DBP Transmission: Dampier Bunbury Natural Gas Pipeline
(DBNGP)

REVIEW OF TECHNICAL ASPECTS OF PROPOSED ACCESS ARRANGEMENT FOR 2021 TO 2025 (AA5)

Report prepared for:
ECONOMIC REGULATION
AUTHORITY OF WESTERN
AUSTRALIA (ERA)

May 2020

Figure 3.5: AA4 variance (Actual capex vs ERA Allowance) for business cases with ERA allowance >\$40k ²⁰

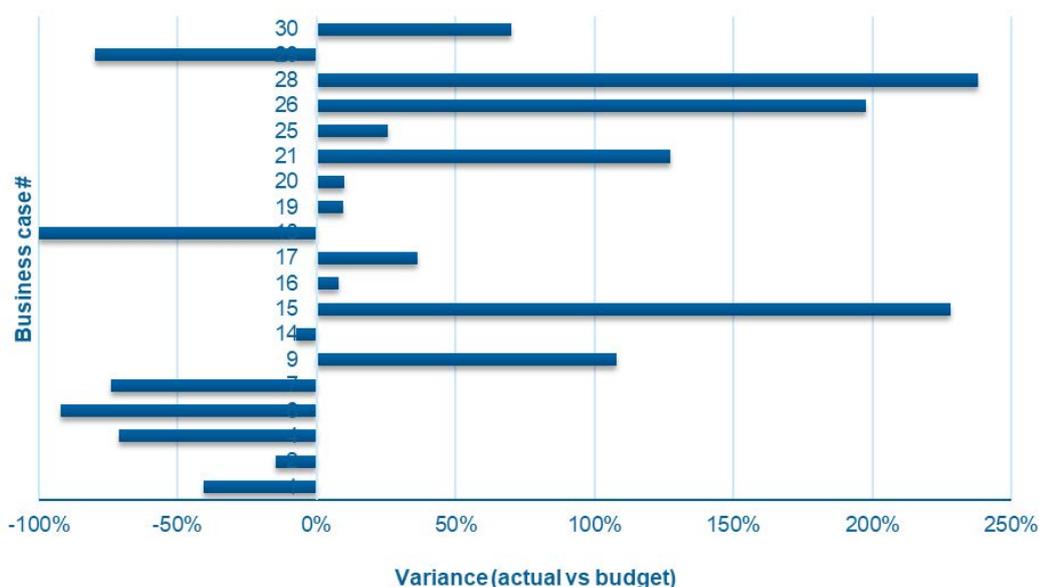
75. AA4 approved capex versus actual capex volatility is pronounced at the business case level. Of the 27¹⁶ AA4 capex business cases, only four¹⁷ were delivered within $\pm 10\%$ of their respective ERA allowance. In the figure below we show the percentage variances for many of the AA4 capex business cases.¹⁸ Eight programs delivered in AA4 had zero or negligible ERA allowance and are not shown in the figure because the variances in percentage terms are extremely high or infinity.¹⁹

Figure 3.9: Number of projects in DBP's work program with 'LOW' untreated risk rating

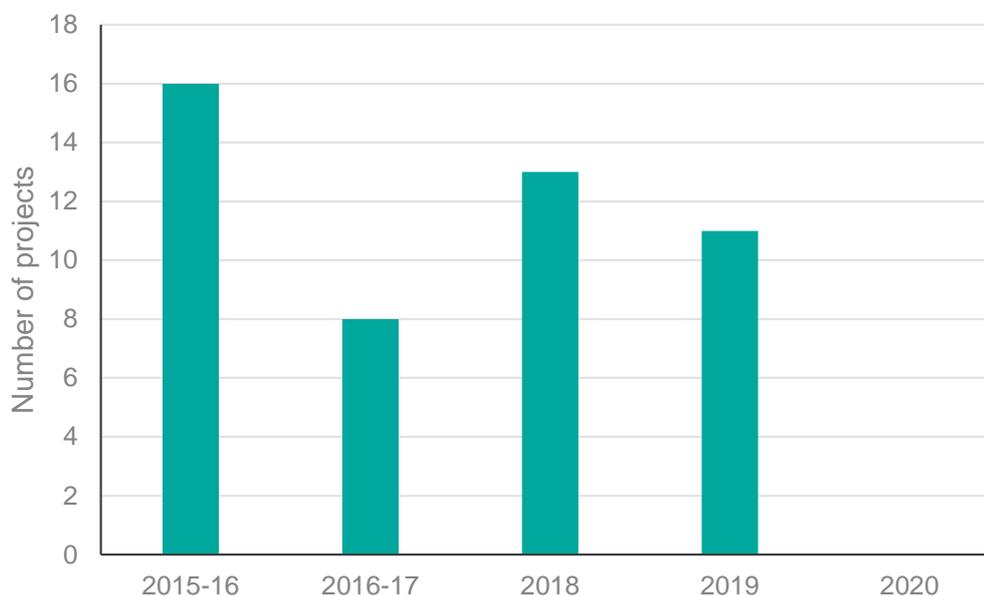
99. The figure below shows that DBP included 48 AA4 projects in four of the five annual project lists to address a highest untreated risk ranking of 'Low'.⁴⁰ DBP's Risk Management Framework states that *Low* and *Negligible* risks are tolerable.⁴¹ Inclusion of these projects appears to contradict the process for optimising the list of programs derived from the 'bottom up' process illustrated in step 3 of Figure 3.2.

DBP has spent approximately \$6.5m out of the \$121.9m (5%) on projects to address low-rated risks. The average amount per project is estimated to be \$135k.

Figure 3.11: benchmark comparison of DBP opex against other regulated gas transmission pipelines (Opex / mmkm – real Dec 2019)⁴⁷

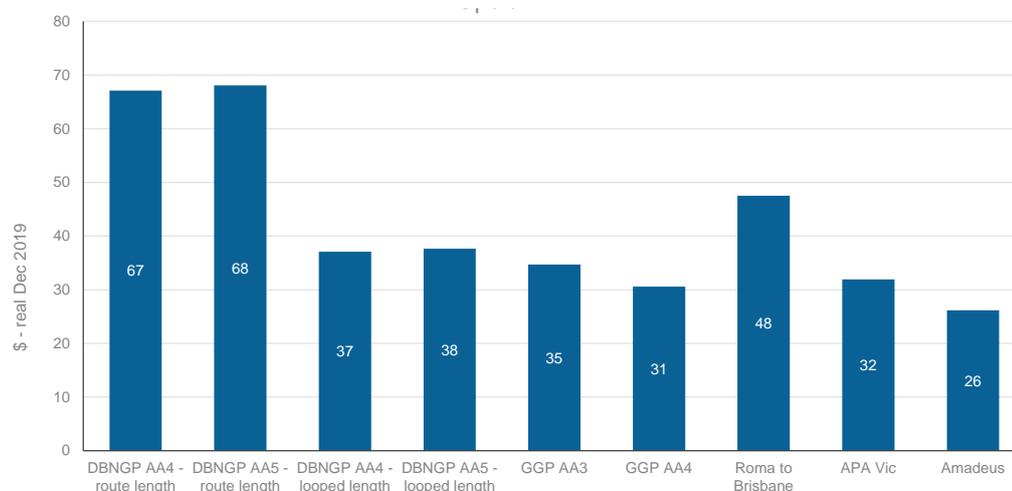
113. In figure 3.11, we show our estimate of a DBP benchmark comparison against four other gas transmission pipelines. Three of these are regulated by the AER;⁴⁶ the other is the Goldfields Gas Transmission pipeline which is regulated by the ERA. We have compared these based on opex per mm-km, where mm represents the pipeline diameter, noting that some of the comparators have published benchmarks also expressed in these terms.
114. Based on route length, the DBP opex is considerably greater than the comparators. However, we have also taken into account that a considerable proportion of the DBP is looped. When we compare its opex on the basis of total pipeline length including looping, the cost falls into the range of other pipelines, though it is higher than the equivalent benchmark for GGP AA3 and AA4.

Figure 5.1: DBP’s actual and forecast throughput (Full Haul Equivalent basis)

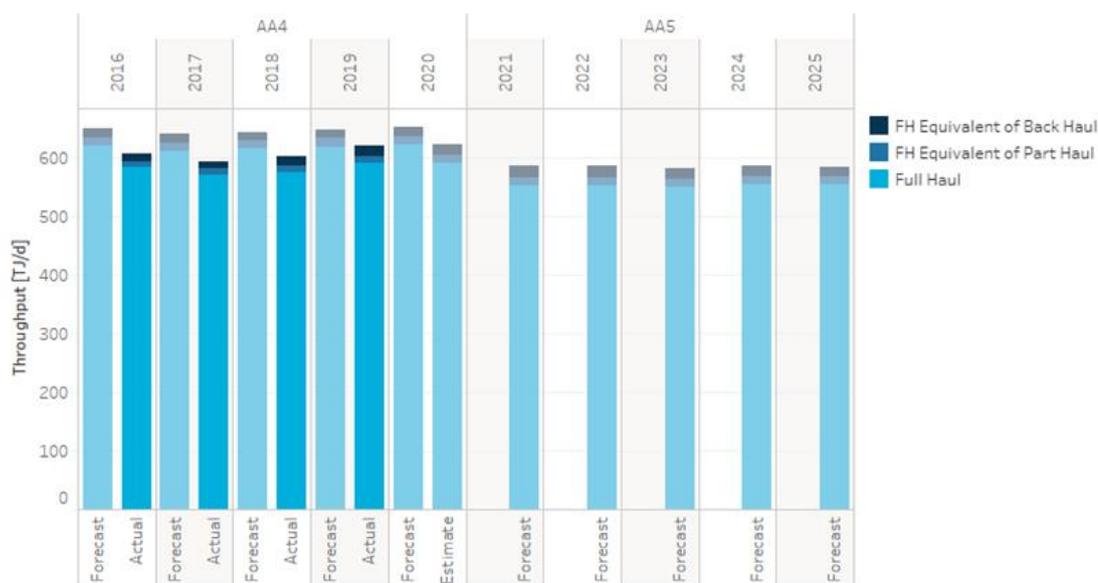
165. The following figure shows DBP’s AA4 actual throughput together with its forecasts for that period, and its current forecasts for AA5. The graph shows that over every year DBP’s actual AA4 throughput (on an FHE basis) has been lower than its forecast. DBP’s AA5 forecast shows a step decrease from 2020 to 2021, and then an essentially flat forecast year-on-year thereafter.

Figure 6.1: DBP AA4 capex and EMCa adjusted - \$m, real Dec 2019

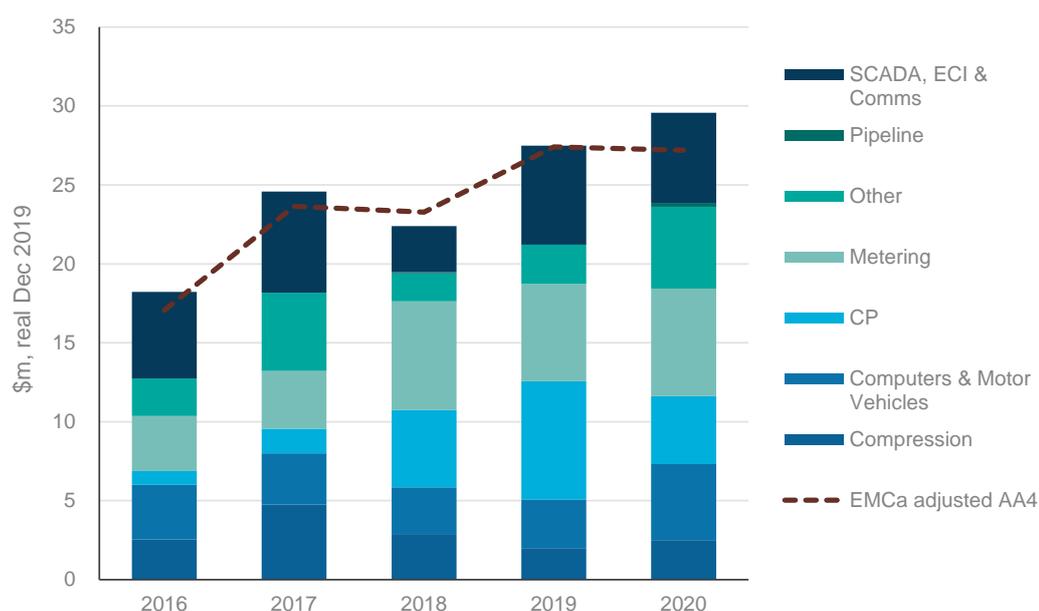
- 290. The following graph illustrates the effect of the assessed adjustments against DBP’s proposed conforming AA4 capex.

Figure 7.9: DBP Proposed AA5 capex and EMCa adjusted - \$m, real Dec 2019

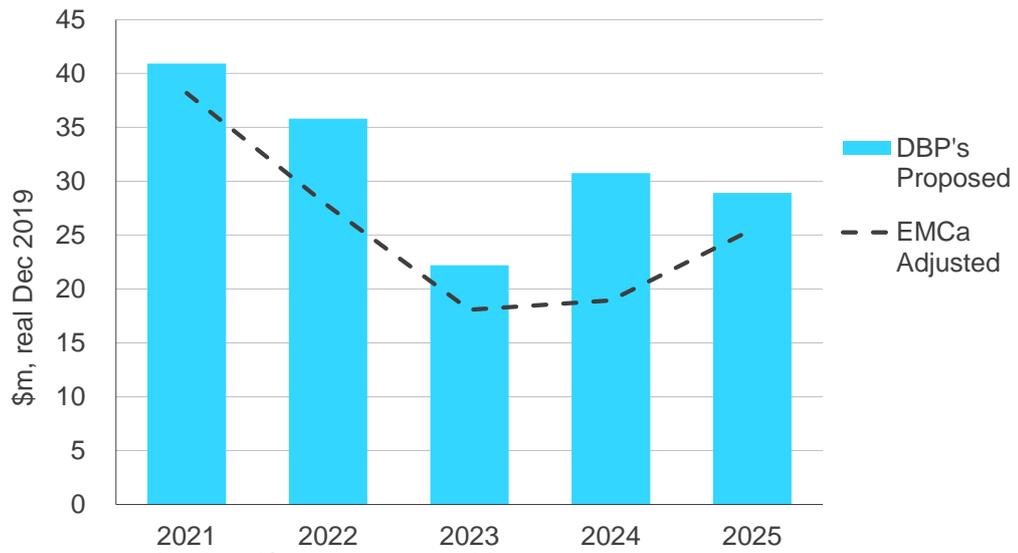
387. We have also adjusted labour escalation by \$1.3m. The total adjustment is therefore - \$30.2m (-19%). The proposed and adjusted amounts are also shown in Figure 7.9 below.

389. The following diagram shows the DBP proposed and EMCa adjusted capex forecasts for AA5.
